SAFETY Notice

Leg Strap Abrasion

February 2007

Photo 1 : A tear on a leg strap

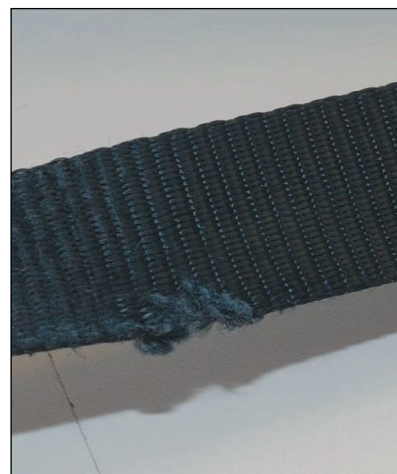
REMEMEMBER : Any damaged carbon seat (see photo 2) may be sharp or abrasive and cause a deterioration of the leg straps and the harness itself. You should always replace such a seat plate.

- If a leg strap is torn (see photo 1), you must not fly with your harness and should return it to a SUP'AIR approved repair centre (details on request).

- If the 2 leg straps do not show any visible damage or perhaps very light abrasion (such as could be expected during normal wear and tear) then it is sufficient to apply a sticky protective strip plus an edging strip. To receive your protection kit, please contact us.
